17-102SPR – BRIDGE PARK, BUILDING A1

Request

Approval of a Site Plan Review to allow for construction of a four-story, ±80,000-square-foot office building and associated site improvements within Block A.

Staff Recommendation

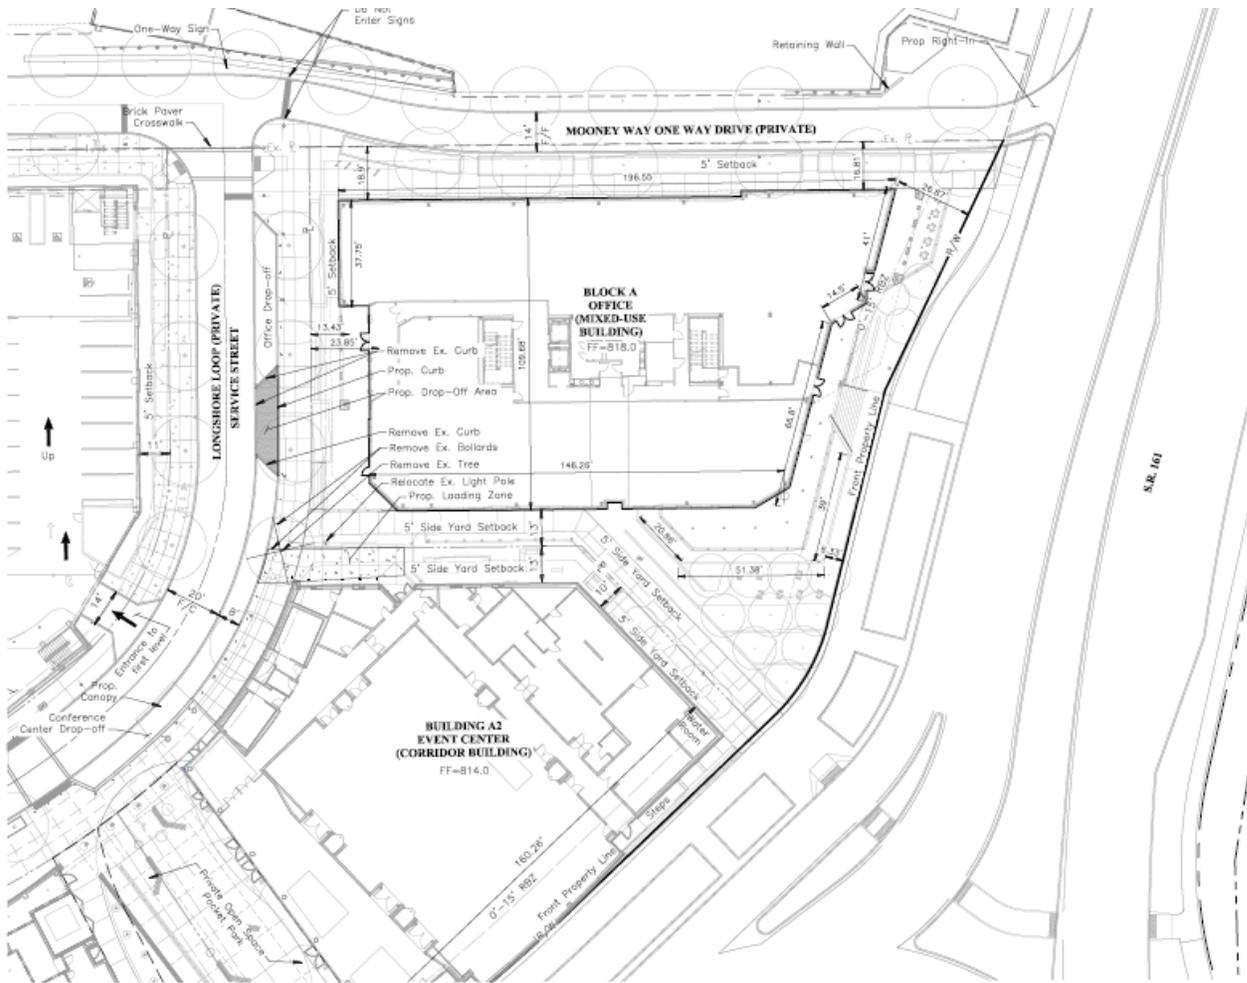
Code requires Pocket Parks to be a minimum of .10-acre and the applicant is proposing $\pm 2,385$ square feet (.05-acre) of open space. A waiver will be required to meet this requirement. While the applicant would meet the minimum size requirement for pocket plazas, the total size of the open space would go over the required maximum for pocket plazas. Staff determined it was most appropriate to review the open space as a Pocket Park since it was most similar to these requirements.

As part of the requirements for adequate fire suppression and to meet the requirements of the Washington Township Fire Department and the City of Columbus, a remote fire connection will be required. The ± 36 -inch tall connection will be located within a landscaped area near the entrance to the mid-block pedestrianway off Riverside Drive. The applicant is working with staff to screen the connection to the greatest extent possible, but still maintain its functionality for fire suppression purposes.

- 2) That the applicant revise the site plan to demonstrate a minimum 14-foot average for the entire pedestrianway.
- 3) That the applicant continue to work with staff to screen the remote FDC unit while maintaining functionality of the unit to the satisfaction of Washington Township Fire Department.
